**INFILL DEVELOPMENT
CONCEPT PLAN**

RESPONSE TO COMMENTS

CAMBRIDGE, MASSACHUSETTS
ISSUED NOVEMBER, 2016

FIGURE. R1.1.1B

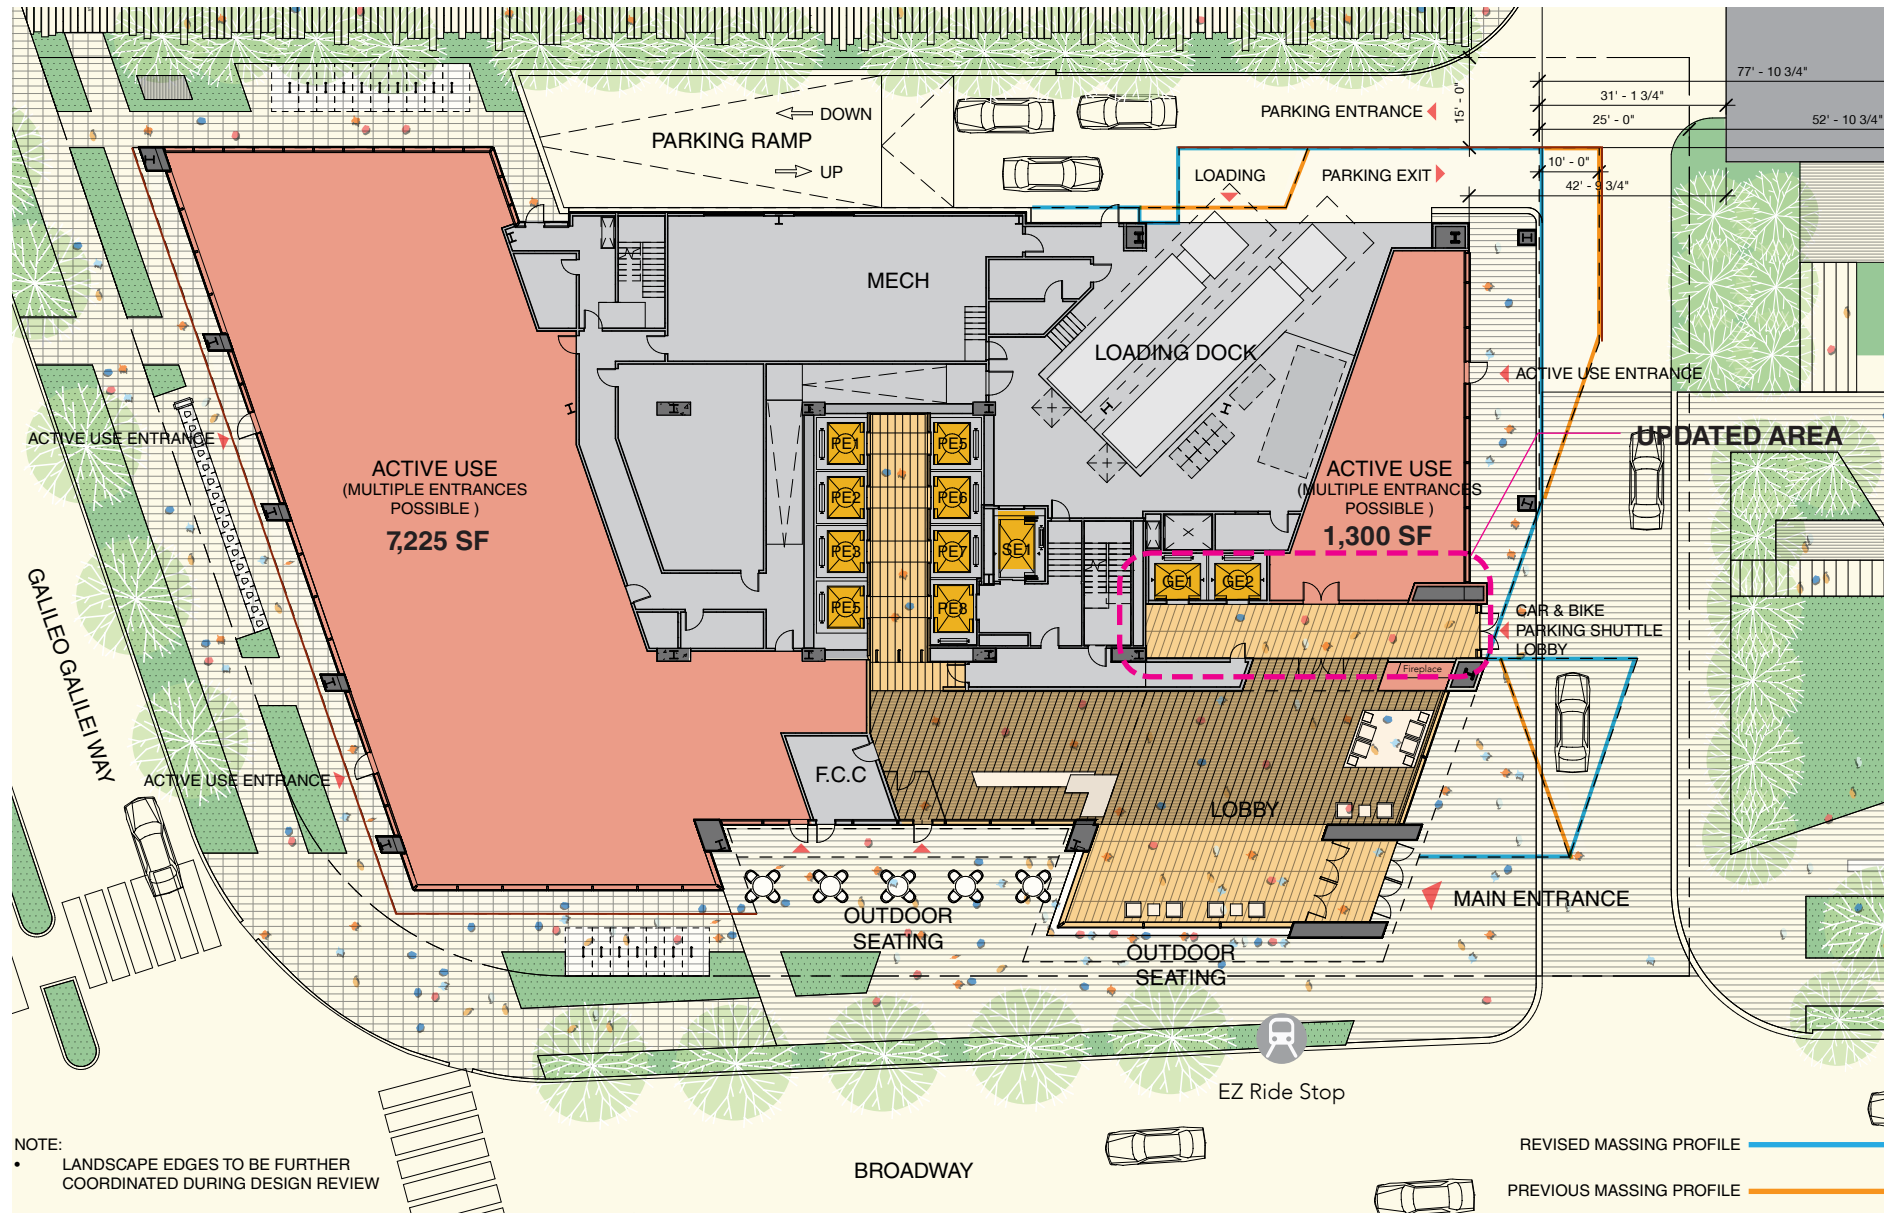
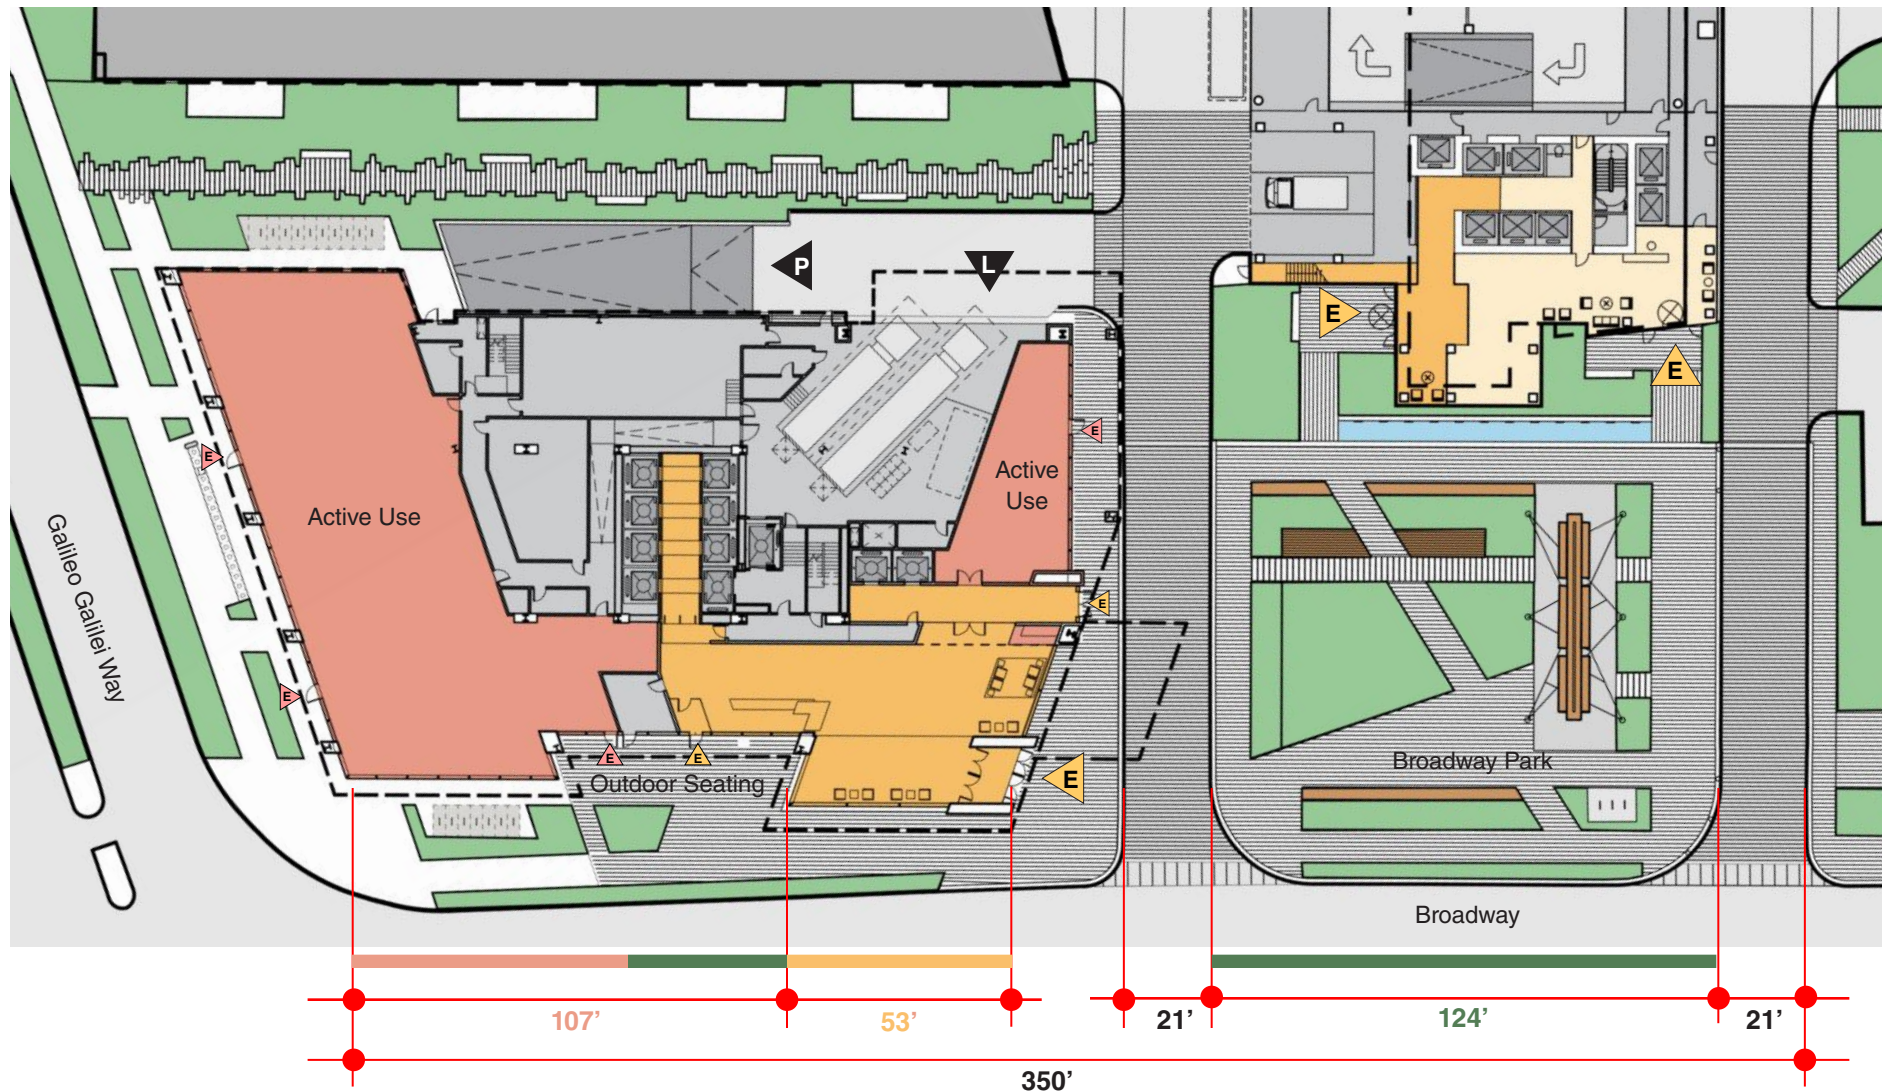
R1.1.1 RETAIL AND ACTIVE USE IN LOBBY: Applicant received several comments and questions about the configuration of the lobby, retail and active use space. The lobby entrance is designed to be oriented toward the corner of Broadway Park both to provide an active use element and to provide further strength to the concept of reconfiguring Broadway Park as an open plaza that connects the entrances of 145 Broadway, 105 Broadway and the South Residential Tower as shown in **FIG. R1.1.1A**, ensuring an active plaza, all times of the day. An updated ground floor plan for 145 Broadway that relocates the garage shuttle elevators to the interior of the building **FIG R1.1.1B**. The result is increased glass line along the park for the northeast retail suite. In addition, the plan provides for outdoor seating along Broadway to increase the active use edge percentage from the 68% detailed in the MXD IDCP August 09, 2016 submission to 75% see **FIG. R1.1.1C**. The retail will be designed with flexibility to ensure multiple options for entrances to accommodate various uses and potential demising plans. **FIG. R1.1.1C** Represents the concept plan's active frontage on Broadway being Retail and Consumer Services or Active Public Gathering Space for a cohesive response to the proposed developments and the public realm

REQUIRED (i) *Retail and Consumer Service* uses, as listed in Section 14.21.3, or (ii) *active public gathering space (whether enclosed or open)*, along a minimum length of seventy-five percent (75%) of the building façade along this frontage.
 $350' - 21' - 21' = 308'$ 75% of 308' = 231'

PROVIDED $107' + 124' = 231'$ (75%)

FIGURE. R1.1.3B

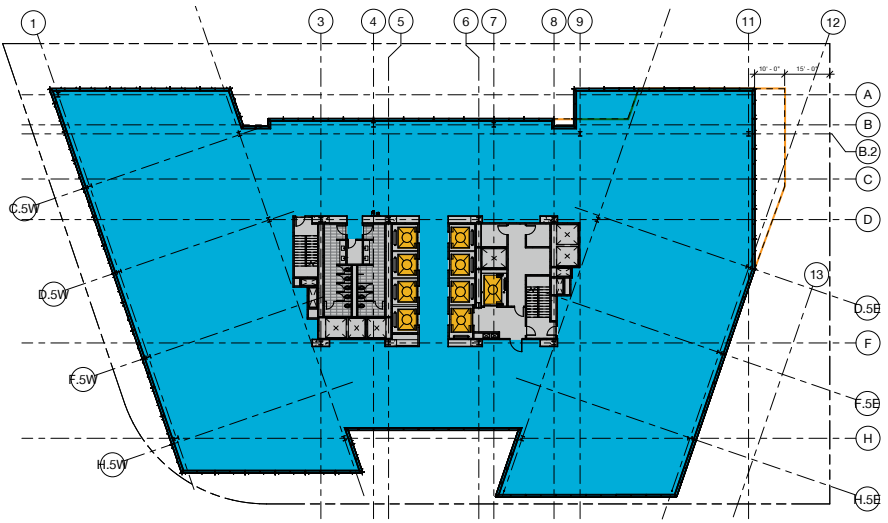
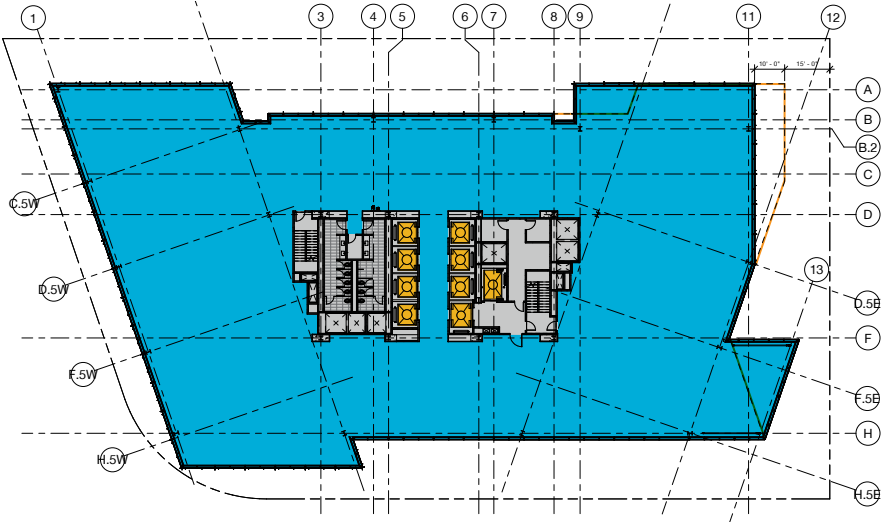
R1.1.3 MASSING AND CANTILEVERS: Applicant received comments about the impact of the 145 massing and cantilevers on the western service drive and Broadway Park. Applicant has made active efforts to ensure 145 Broadway is not only designed to ensure internal usability and flexibility but is also visually interesting from the street with multiple expansions and contractions. In addition, the design as proposed provides a distinctive and interesting approach to the scaling goals that are part of the K2 datum height and podium guidelines. Applicant has reviewed the proposed massing in the context of creating a functional and interesting building, along with K2 guidelines and concerns over cantilevers expressed in the comments. **FIG. R1.1.3A** and **FIG. R1.1.3B** shows a massing that reduces the cantilevers along the western service drive by 10 feet, reorients the southeast cantilevers towards the street to create visual connection and still maintains the interest and scaling inherent in the original design intent.

FIGURE. R1.2.1

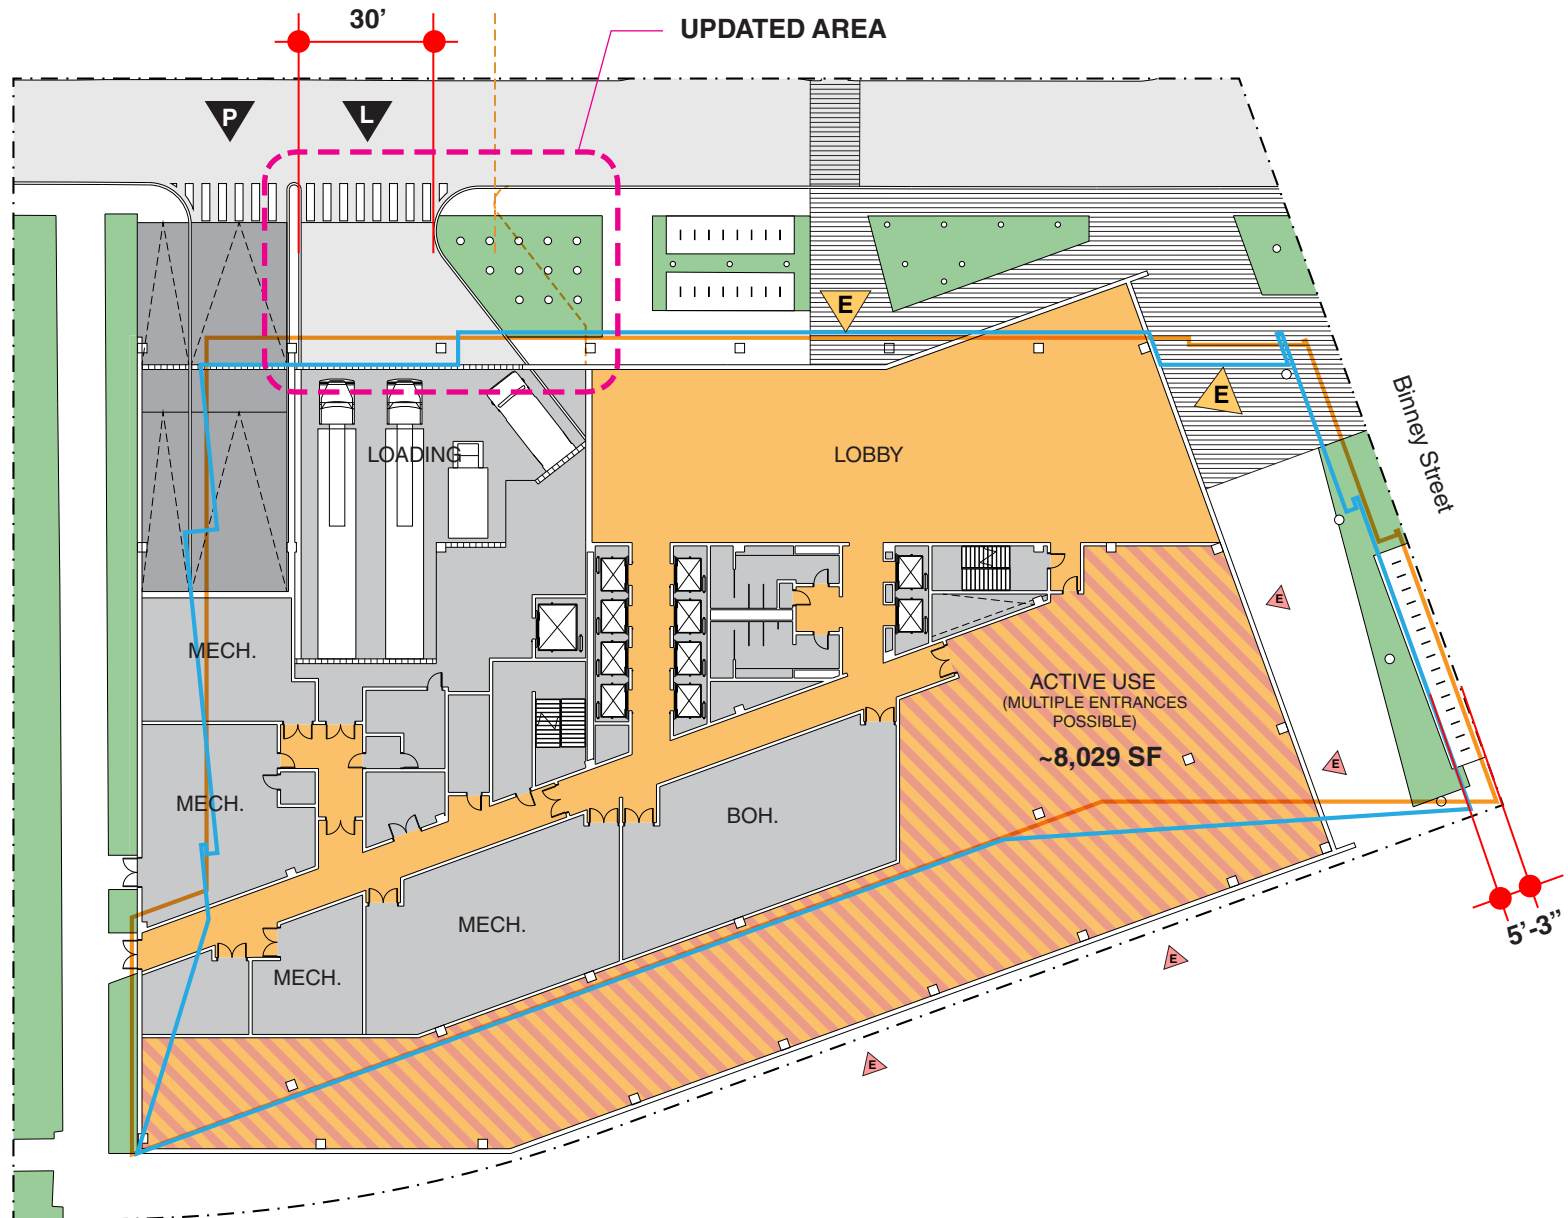
R1.2.1 FLOOR PLATE SIZE: Applicant has received comments regarding the size of the floor plates at of 250 Binney Street. The 250 Binney building is being designed to support programmatic flexibility for both potential office and laboratory tenants. In the current market context, both within the Kendall Square submarket and the broader Boston market, many creative and technology firms are seeking large, open floor plates in order to foster connectivity and communication between their workforce and ease of configuration for a variety of space planning possibilities. The typical floor plate at 250 Binney Street is targeted at 30,000 Gross Square Feet, which is consistent with current market demand. The floor plate is also a product of efficient and effective core to exterior wall dimensions that foster the kind of programmatic flexibility necessary to be competitive in the market and attract excellent long-term tenants.

R1.2.4 LOADING DOCKS: CDD staff has noted that the curb cut at the loading dock is wider than the 30' recommended by K2. The loading dock has been thoughtfully located at the interior most corner of the site, off of the internal service drive, which protects it from view from the public streets. It is located directly adjacent to the garage access, so that the impact of these two uses on the overall façade and pedestrian experience can be minimized as much as possible. The design will include loading dock doors and additional design measures have been implemented to minimize its visual impact along the service drive, such as recessing it from the primary façade and forming the streetscape to minimize the curb cut as much as possible. A buffer has been added between the garage entry and the loading dock and the curb cut has been narrowed to 30' by extending the sidewalk zone further south and angling the drive leading to the loading dock. **FIG. R1.2.1**

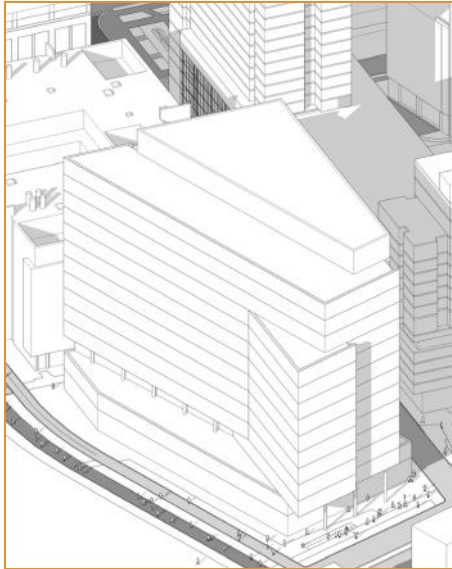
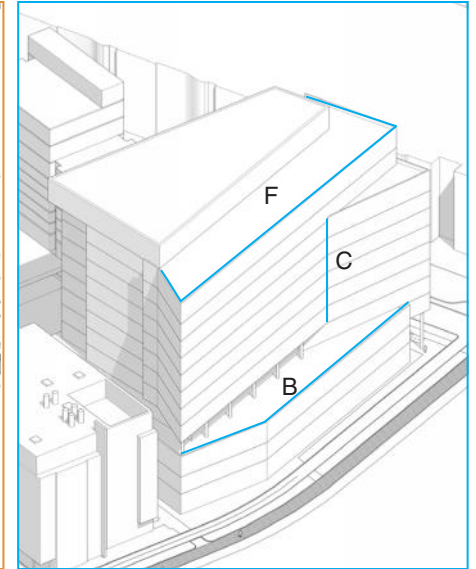
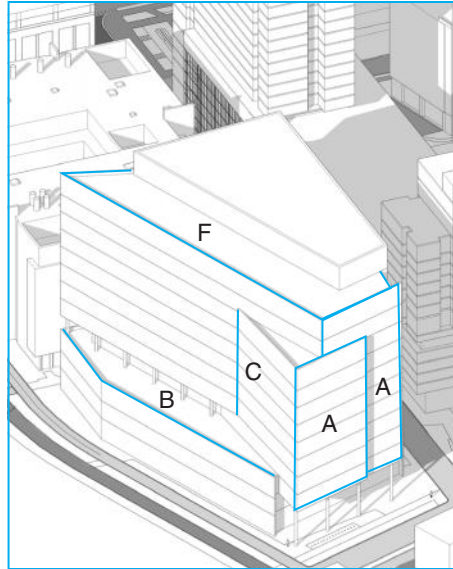
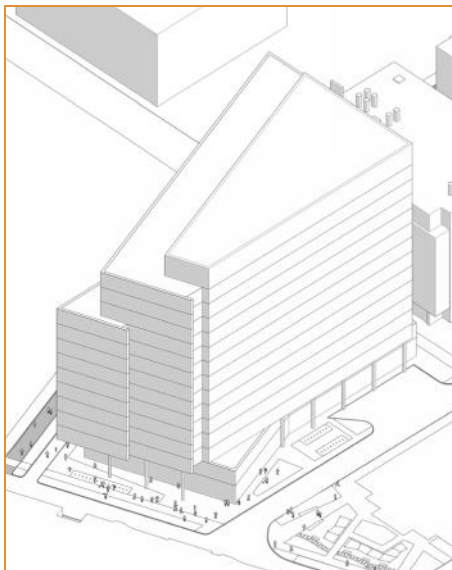
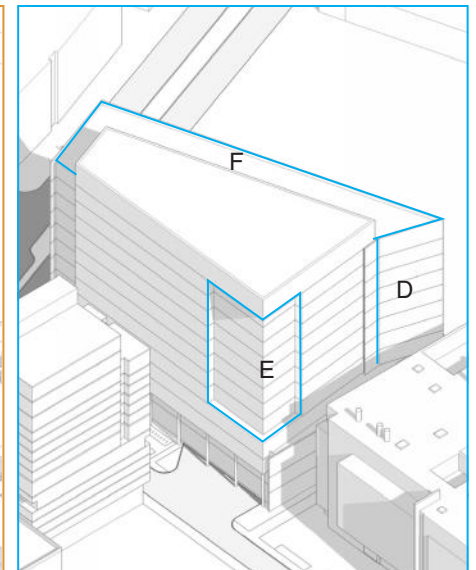
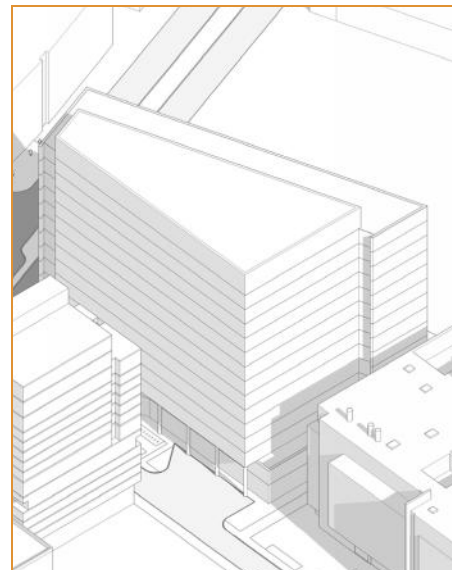
R1.2.2 MASSING: Applicant has received comments about the massing and form of 250 Binney Street. Two comments were received regarding the Binney Street façade, the proposed overhang and the pedestrian experience along the street. As shown in **FIG. R1.2.2**, a number of design evolutions have been made to address these concerns. The entire Binney Street façade has been pulled south 5'-3" to provide more setback from the property line and street (**A**). The first two floors have also been pulled in on the northern and western sides to allow for increased pedestrian circulation and to create a more generous arcade (**A'**) and gathering space on the site across from the Binney Park. In addition, the edge of the western façade element has been pulled south to create a deeper reveal between two of the volumes and a more cohesive relationship with the opposite end of the revised western façade. Lastly, as further discussed below, the proportions of the overhanging volume have been adjusted to make it feel more integrated into the overall design. Other comments focused on the height of the podium component along the 6th Street Connector and the length of the eastern façade. **FIG. R1.2.2** shows proposed massing modifications designed to address these concerns. The podium has been increased from 2 to 3 stories (**B**) and the projecting volume at the corner of Binney Street and the 6th Street Connector has been modified to pull the intersection point between the two eastern volumes further south (**C**). This had the effect of decreasing the uninterrupted length of the eastern façade and by differentiating the two components, creating a dynamic and visually interesting corner at Binney Street. Additionally, comments were received on the proximity of the southern façade to the abutting building and the uninterrupted length of the western façade along the service drive. As shown in **FIG. R1.2.2**, to address these comments, the southern façade has been angled in at the center (**D**) creating more visual separation along the pedestrian connector and giving the façade more movement. Along the western façade, the team has modified the design to include an inset corner at the southwest corner of the building. This strategy helps to break down the massing and length of the façade (**E**).

PODIUM INCREASED FROM 2 TO 3 STORIES

SETBACK FROM BINNEY STREET

INCREASED PEDESTRIAN CONNECTION WITH LARGER ARCADE

PROJECTING VOLUME AND INTERSECTION BROUGHT FURTHER SOUTH
